30 January 2013

SKM Report 300113
EN02224

**Technical Review of AECOM (25 October 2012) HHERA for the
Declared Area and Adjacent Land, Barangaroo, Hickson Road, Sydney**

■ **Figure 2-1 Estimated Extent of Shallow Groundwater Exceeding Short-term Risk Target Criteria**

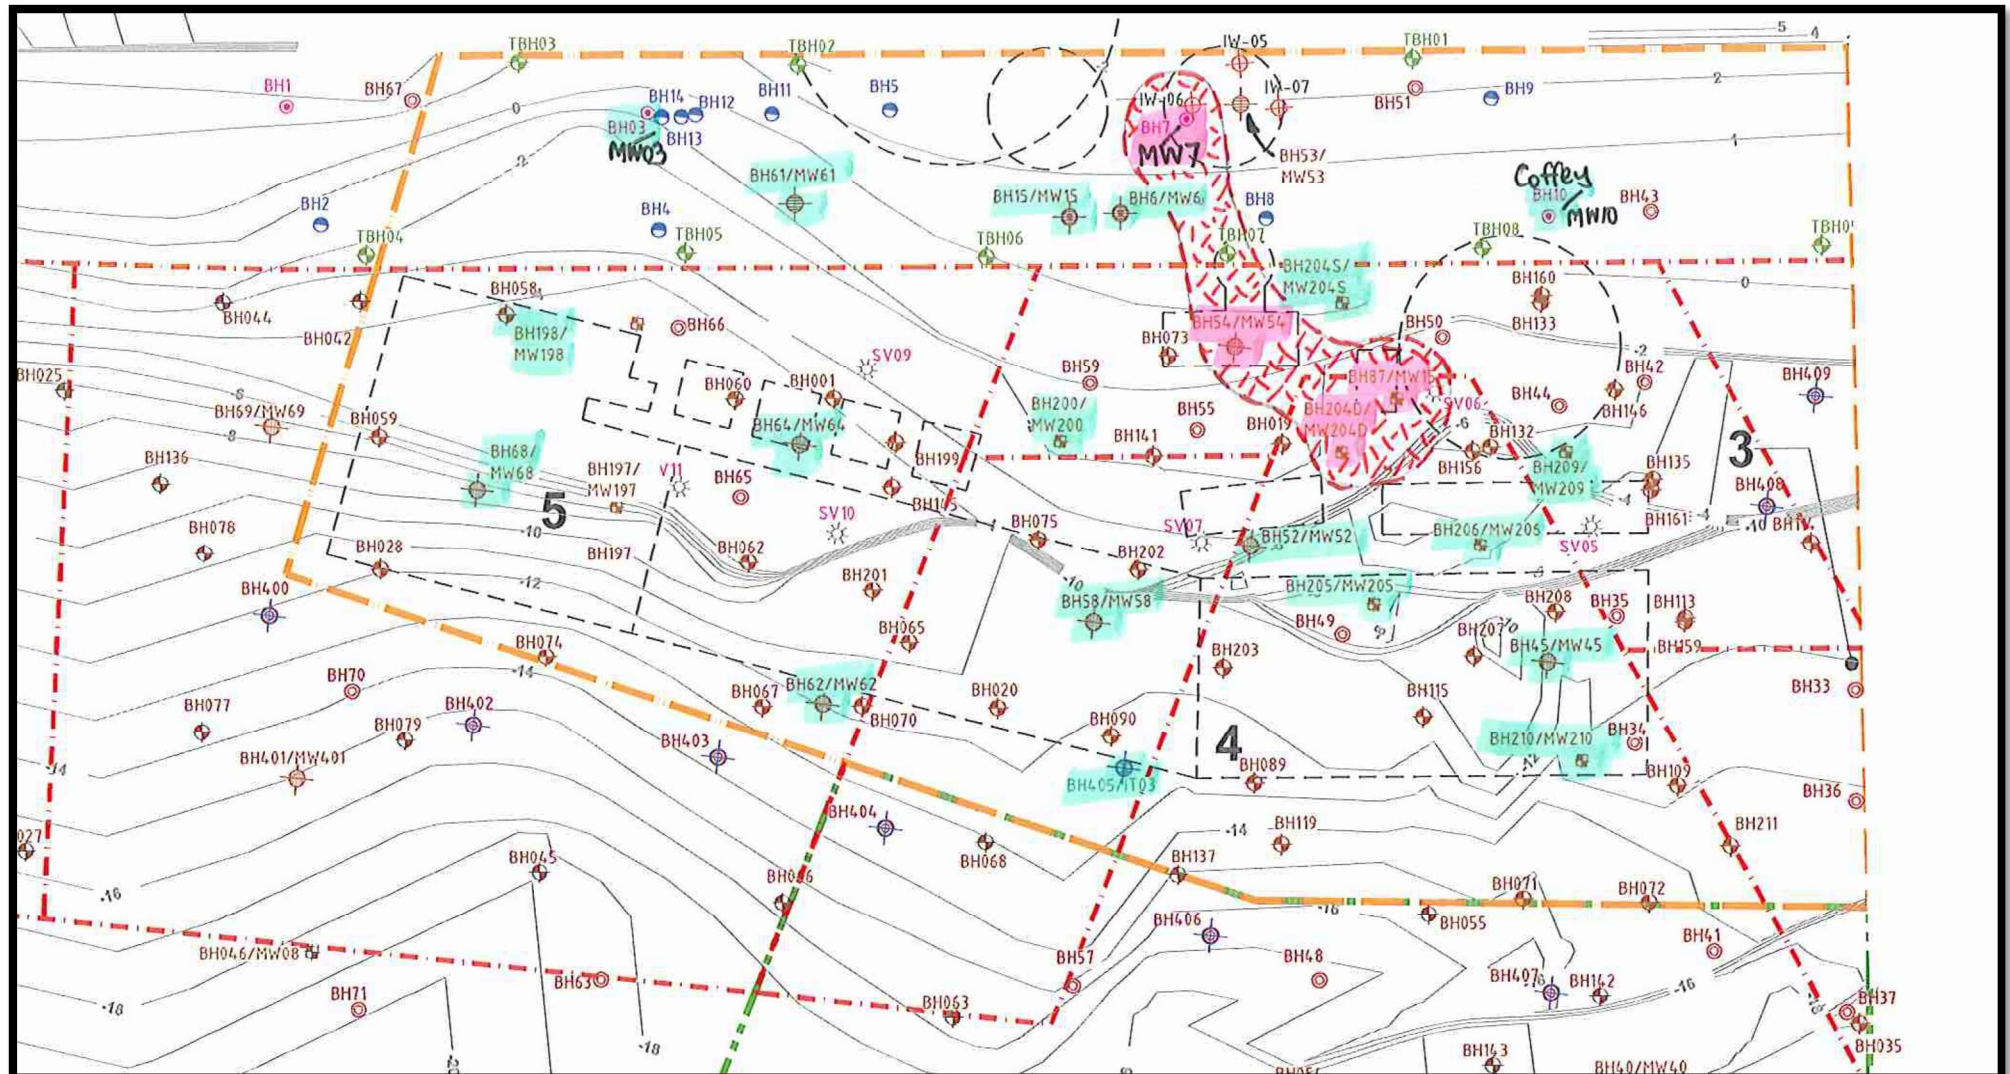
- No soil at the *Declared Area* poses an unacceptable health risk;
- No groundwater at the *Declared Area* poses an unacceptable long-term health risk;
- Groundwater across practically the whole of the *Declared Area* (95%) does not pose an unacceptable short-term health risk; and
- Groundwater poses an unacceptable short-term health risk to an unprotected maintenance worker in a small localised part of the *Declared Area* (5%), with the estimated extent of this area shown in **Figure 2-1**. The area is located at/near buried tar tanks, gasholders, and an abandoned sewerage pump station SPS59.

■ **Figure 3-1 AECOM CSM for the Declared Area**

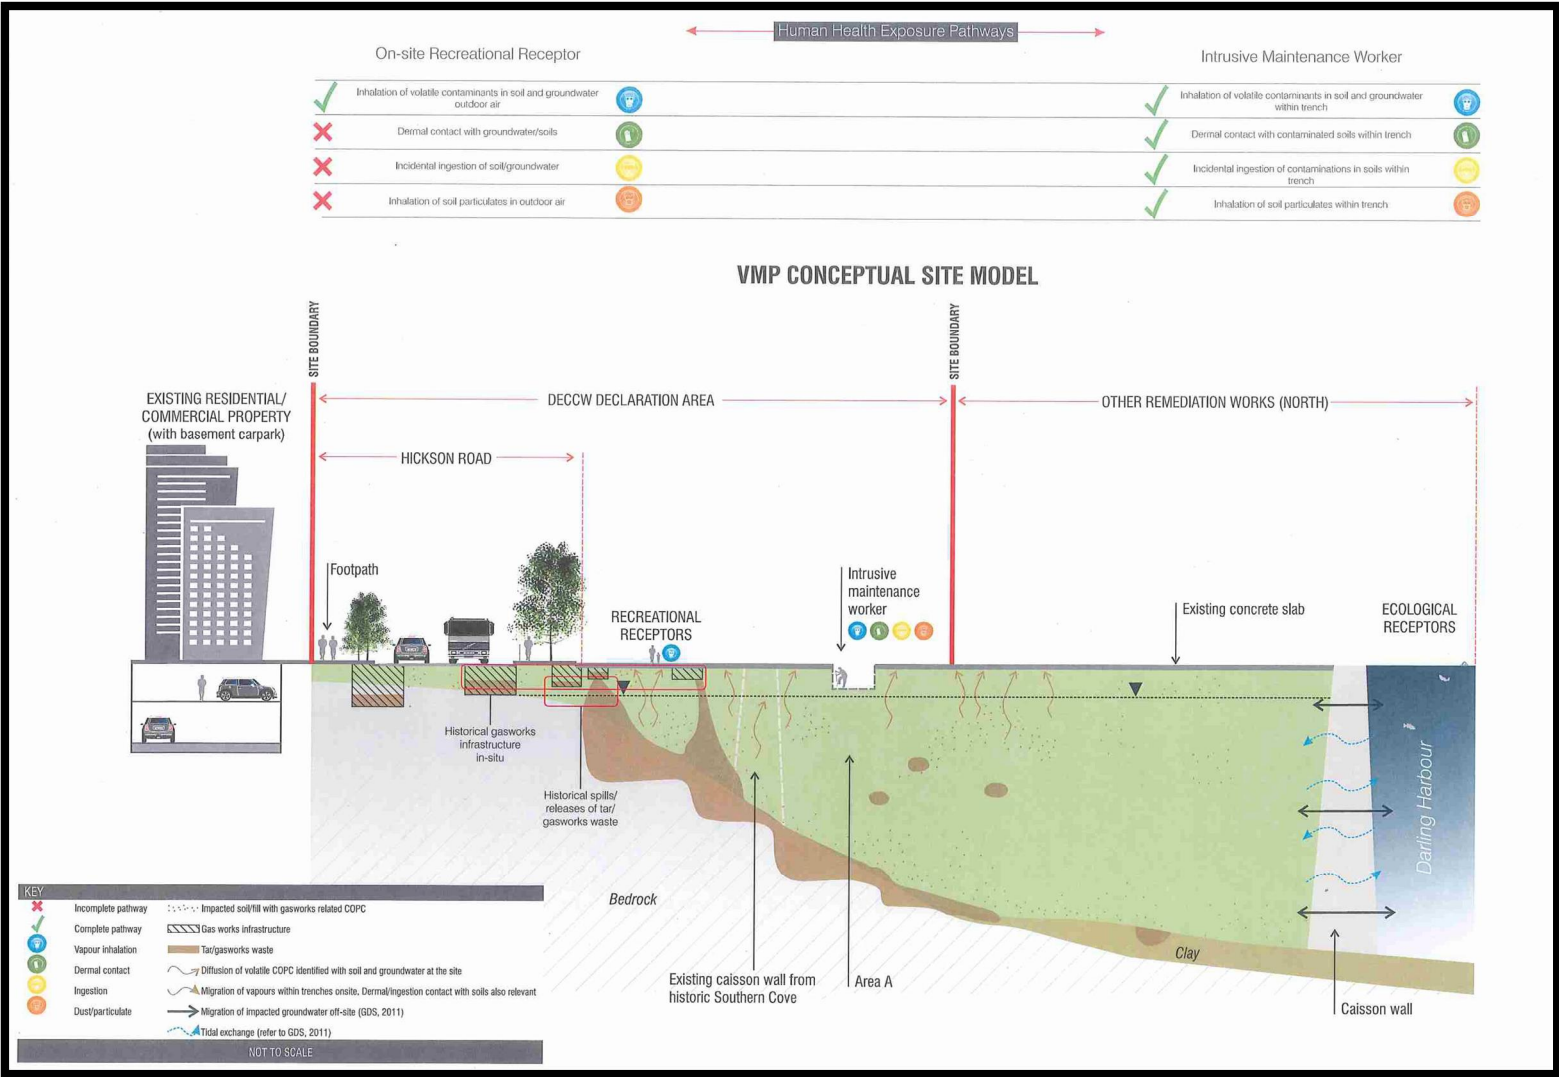
In my opinion, the CSM presented in the AECOM HHERA contained deficiencies that have caused major errors in the conclusions and recommendations made by their study. The following subsections describe the deficiencies concerning how the AECOM CSM assessed and/or modelled contaminant sources (**Section 3.2**), contaminant release mechanisms (**Section 3.3**), the extent of contamination (**Section 3.4**), potential receptors (**Section 3.5**), and contaminant migration pathways (**Section 3.6**).

However, the AECOM CSM and other parts of the AECOM HHERA did not assess and describe the dominant release mechanism for contaminants from these sources, particularly in relation to how these tarry wastes are impacting groundwater within the fill layer, which migrates westwards towards Darling Harbour. The only reference to this issue made by the AECOM HHERA was a comment on the CSM figure that mentioned the presence of “*historic spills / releases of tar / gasworks waste*” in AECOM Figure F6 (**Figure 3-1**).

■ **Figure 4-1 Investigation Locations at Declared Area**

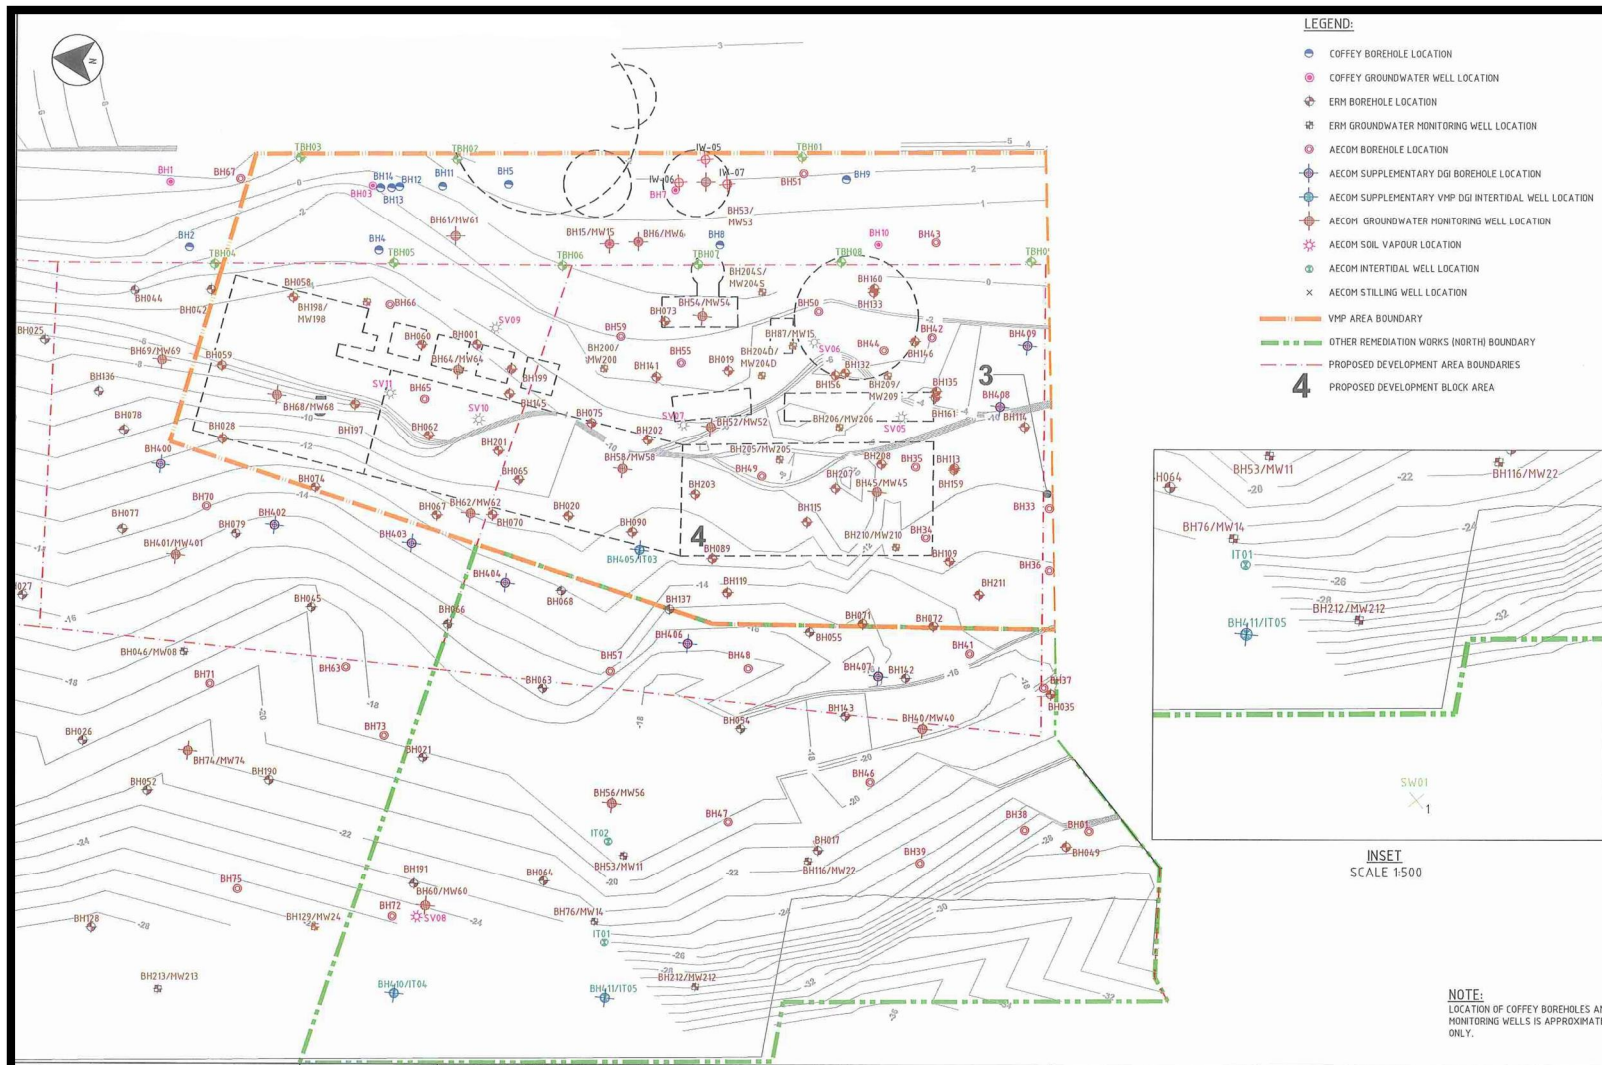
The AECOM HHERA assessed environmental risks based on groundwater data collected from all wells located across the *Declared Area*, irrespective of where the well was located relative to the closest ecological receptor. This meant that groundwater data from wells located in a buried tar tank or gasholders along the eastern side of the *Declared Area* were used to assess potential environmental impacts to the closest ecological receptor, this being the marine ecology in Darling Harbour located to the west of the *Declared Area*. AECOM justified their approach because they considered there were uncertainties regarding whether existing groundwater monitoring results are representative of groundwater leaving the western boundary of the *Declared Area*⁶⁵.

■ **Figure 5-1 AECOM Conceptual Site Model for Unprotected Maintenance Worker**

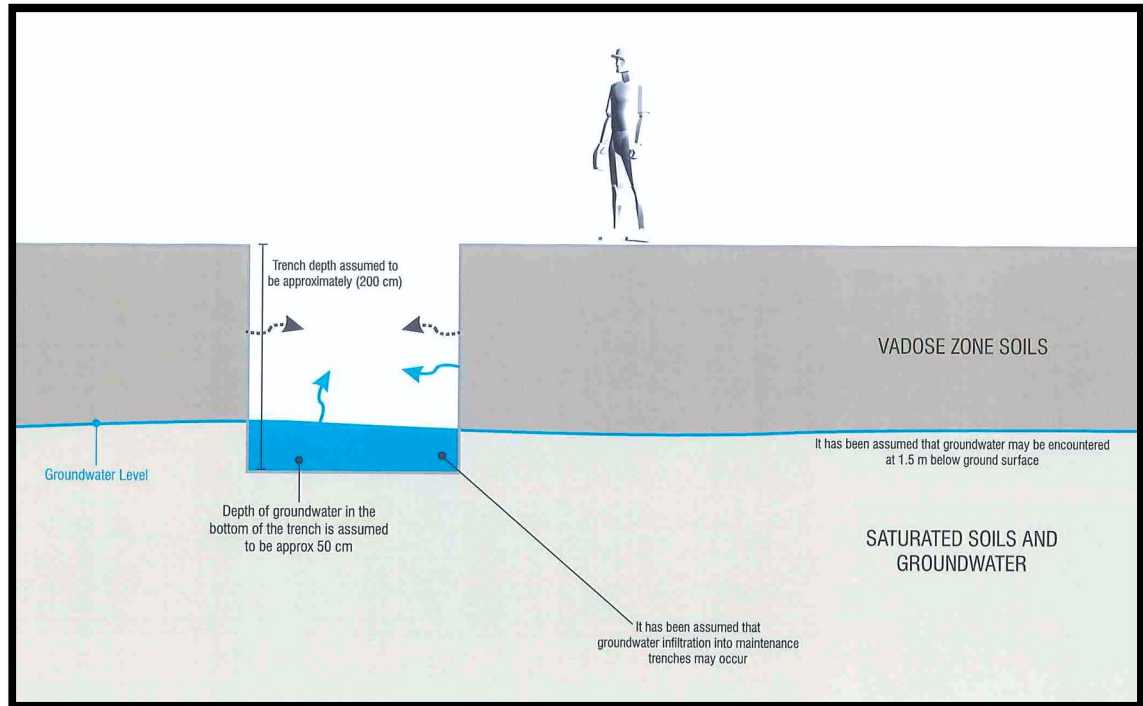
- A recreational user of the area who walks over the concrete/asphalt pavement; and
- An unprotected maintenance worker undertaking short term intrusive work in a trench 2 m deep and 2 m long. AECOM allowed this worker to be exposed to contaminated soil located in the sides and floor of the trench, contaminated groundwater that was assumed to be present in the trench from a depth of 1.5 m to 2.0 m below ground level (bgl), and vapours generated by contaminated soil and groundwater (**Figure 5-1**)⁸⁷.

- It was unrealistic for the AECOM HHERA to assume that a maintenance worker undertaking short term intrusive work in a trench at a contaminated site would be unprotected and not wearing any personal protective equipment (PPE) capable of mitigating any health risk. This is because:

■ **Figure 5-4 Estimated Extent of Shallow Groundwater Exceeding AECOM Acceptance Criteria**

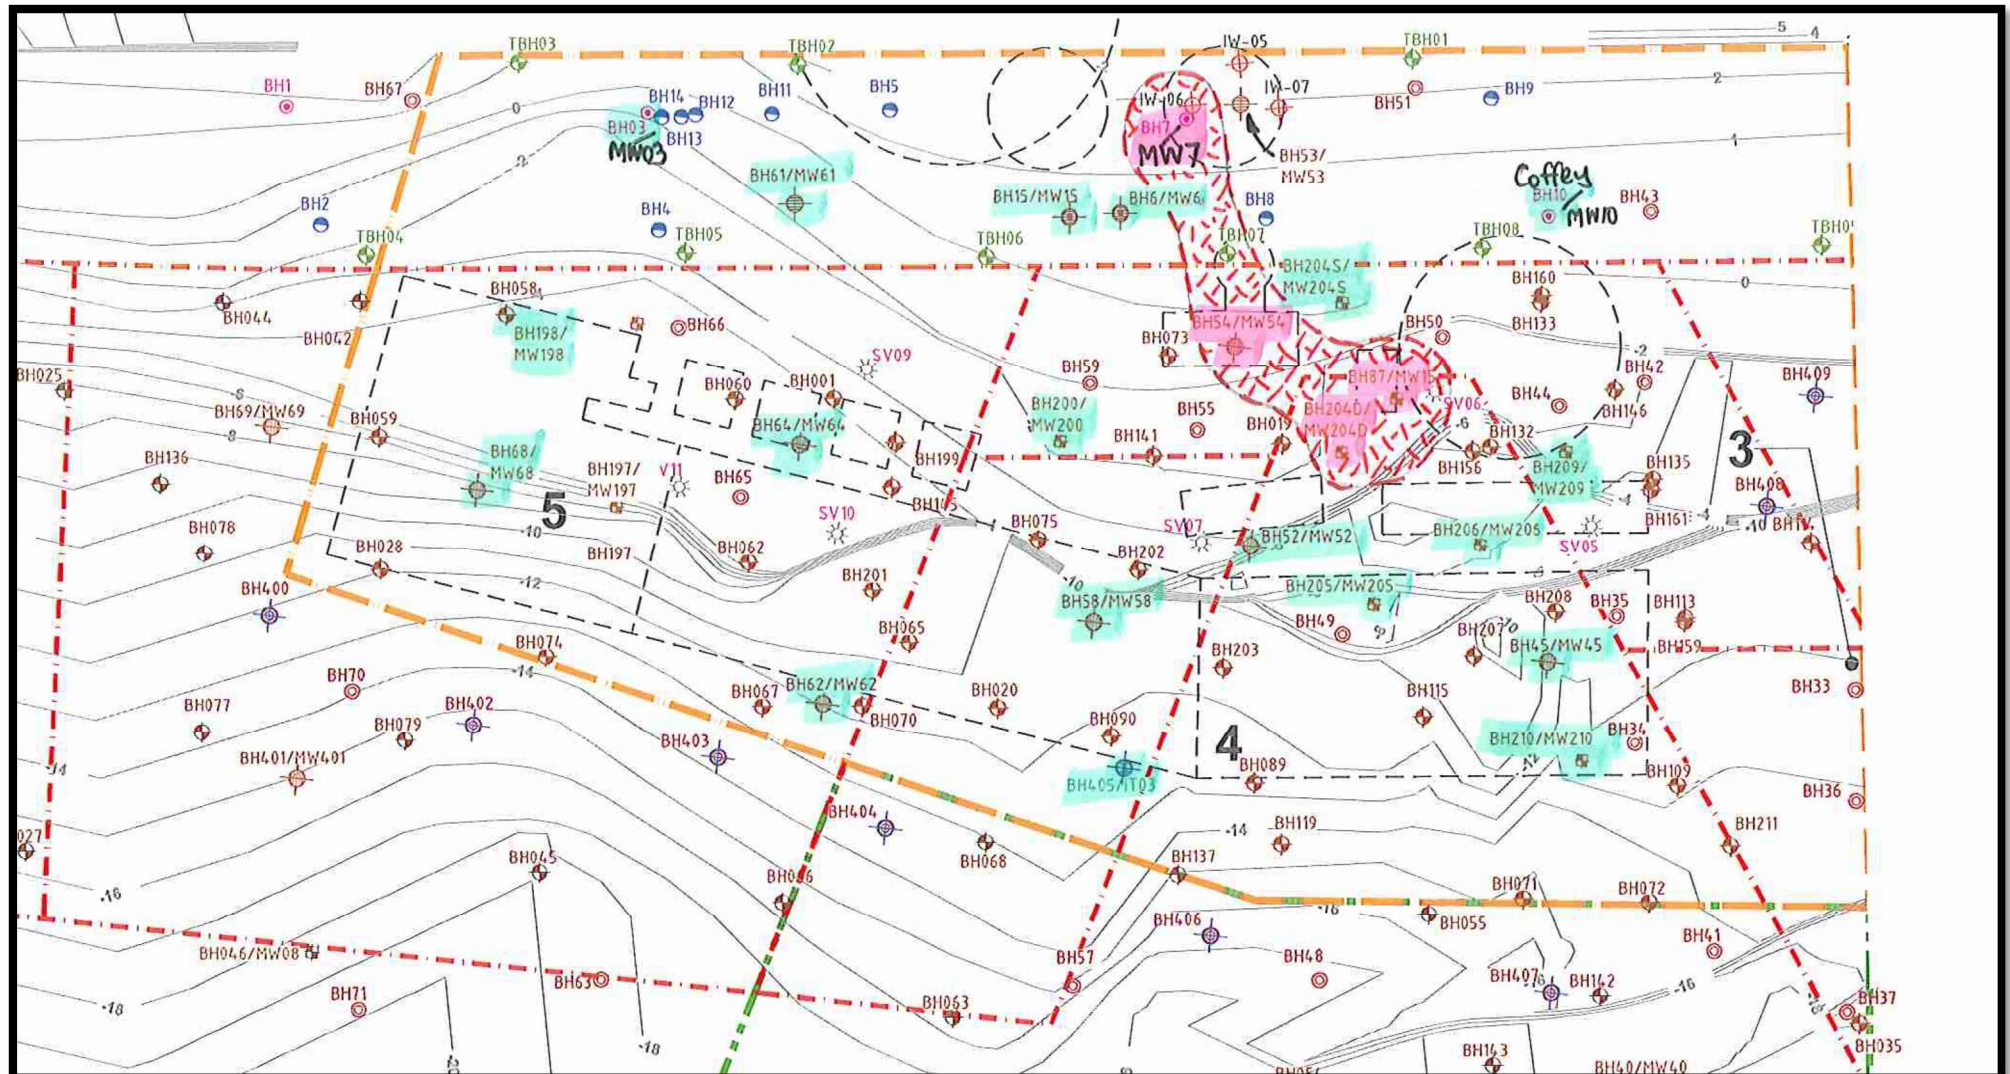
In my opinion, the health risks to an unprotected maintenance worker should have been calculated using only groundwater samples collected in fill where the water table lies above the base of a 2.0 m deep trench. This is because:

The available data also indicate that most of the wells that have been monitoring shallow groundwater (≤ 2 m bgl) at the *Declared Area* have measured concentrations below the AECOM acceptance criteria. Only 4 wells have measured concentrations that exceed the AECOM groundwater acceptance criteria. These wells are situated in a localised area bounded by the abandoned sewerage pump station SPS59, a buried tar tank and the buried remains of the 1870 gasholder. The extent of this shallow groundwater plume is estimated to represent 5 % of the *Declared Area* and is shown in **Figure 5-4**.
